Access Compliance Report

Public Rights-of-Way

(Curb Ramps)

Intersection ID: 44333	Main Street: BROWNE_RD	Cross Street: RETRIEVER_WY	Location: SE
ADA ID: DED9F6912E3D	Ramp Type: Perp	Initial Pass/Fail: Fail	Overall Compliance: No
Severity Score: 12.5			
Codes/Mitigation Info/Possible Solution		Field Measurements/Component Compliance

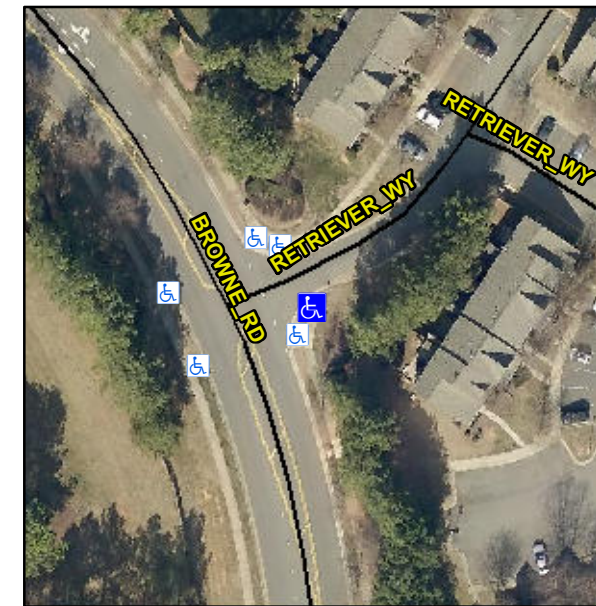
Compliance	Description	Data	Compliance	Description	Data
N/A	Ramp Length (in)	63.5	No	Ramp Slope (%)	11.7
Yes	Ramp Width (in)	48.0	Yes	Ramp XSlope (%)	2.0
N/A	Flare Type LT	N/A	N/A	Flare Type RT	N/A
N/A	Flare Slope LT (%)	N/A	N/A	Flare Slope RT (%)	N/A
N/A	Flare Traversable LT?	N/A	N/A	Flare Traversable RT?	N/A
N/A	Landing Length (in)	N/A	N/A	DWS Provided?	N/A
N/A	Landing Width (in)	N/A	N/A	DWS Contrast?	N/A
N/A	Landing Slope (%)	N/A	N/A	DWS Length (in)	N/A
N/A	Landing X Slope (%)	N/A	N/A	DWS Full Width?	N/A
N/A	Landing Curb? (Y/N)	N/A	N/A	DWS Offset (in)	N/A
N/A	Shared Landing?	N/A			
N/A	Gutter Ponding?	N/A	N/A	Gutter Slope (%)	N/A
N/A	Gutter Lip Ht (in)	N/A	N/A	Gutter X Slope (%)	N/A
N/A	Painted X Walk1?	No	N/A	Painted X Walk2?	N/A
	X Walk 1 Direction	To N		X Walk 2 Direction	N/A
N/A	X Walk 1 Width (in)	N/A	N/A	X Walk 2 Width (in)	N/A
	X Walk 1 Slope (%)	3.2		X Walk 2 Slope (%)	N/A
	X Walk 1 X Slope (%)	3.1		X Walk 2 X Slope (%)	N/A

Remove & Replace Entire Ramp.

R304.2.2
